PLANNING CLEARANCE *Single family Home*
 (site-plan review, multi-family development, non-residential development)
Grand Junction Community Development Department

BUILDING ADDRESS 2360 Rana Rd GJ Co. TAX SCHEDULE NO. 2945-174-36-004
 SUBDIVISION Ridges SQ. FT. OF PROPOSED BLDG(S)/ADDITION 1872
 FILING GB BLK _____ LOT 4A SQ. FT. OF EXISTING BLDG(S) 0
 OWNER Troy & Teresa Robinson NO. OF DWELLING UNITS: BEFORE 0 AFTER 1
 ADDRESS 615 E. Indian Creek Dr. NO. OF BLDGS ON PARCEL: BEFORE 0 AFTER 1
 TELEPHONE 970-245-1507 USE OF ALL EXISTING BLDGS Residence
 APPLICANT Same as DESCRIPTION OF WORK & INTENDED USE: _____
 ADDRESS Above Construct new home
 TELEPHONE _____

► APPROVAL FOR BUILDING PERMIT ◀
Ridges Architectural Control Committee (ACCO)

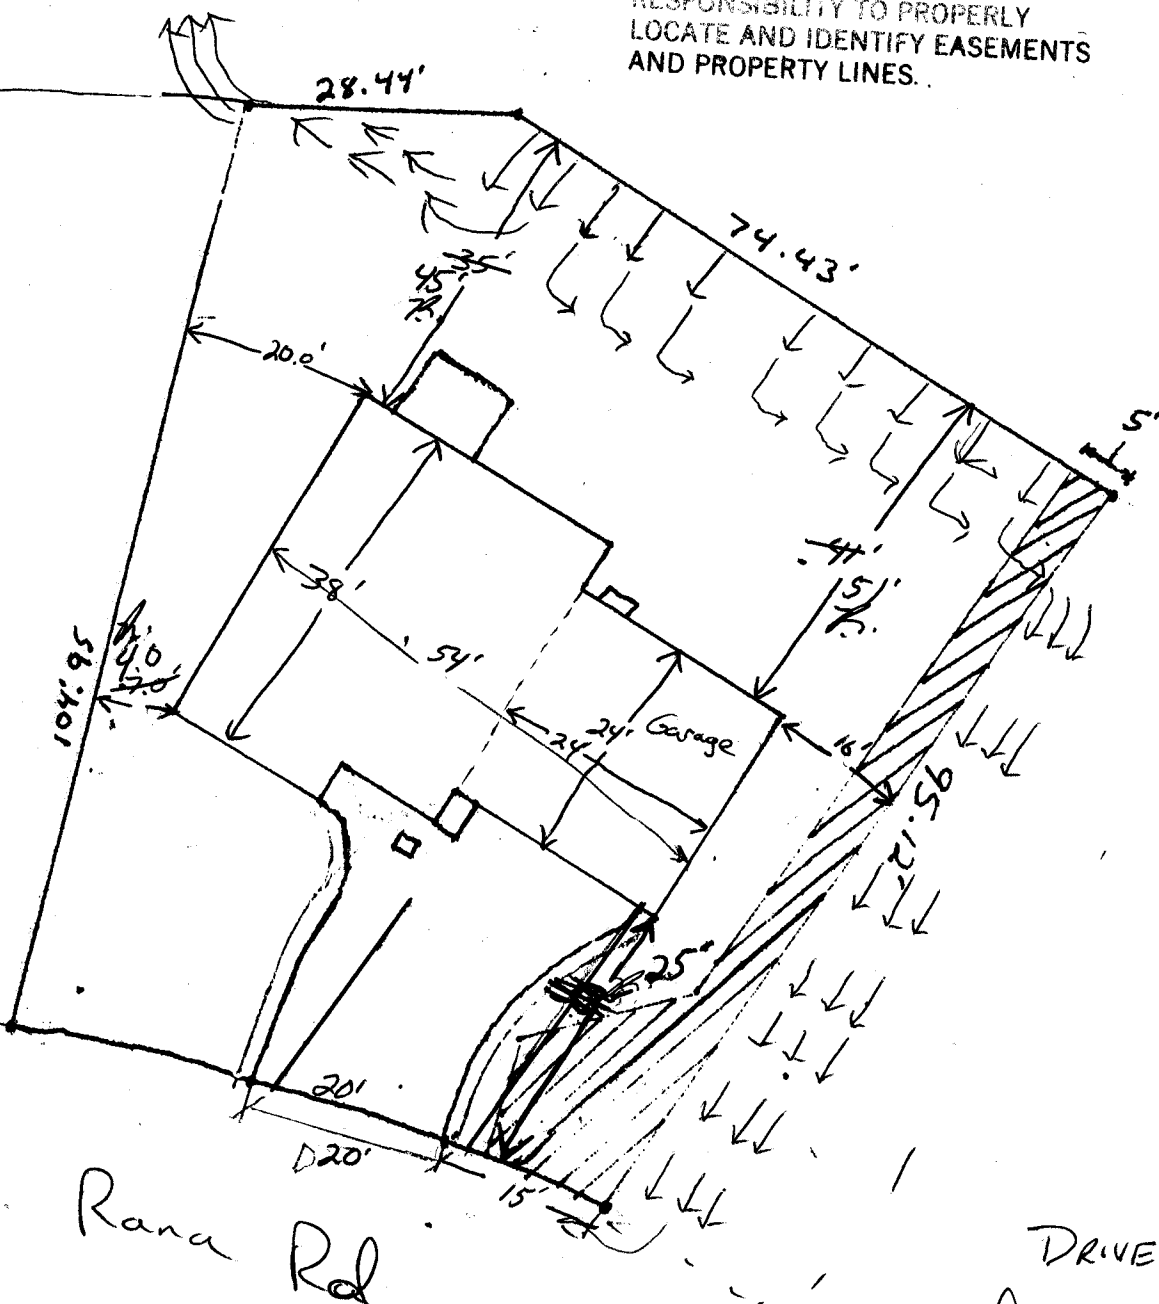
DRIVE OK
Dave de Souza
 5/4/01

Provide Dimension D;
 must be $14 < D < 30$ ft
 Drive OK as noted.
 D.D.D.
 2/12/01
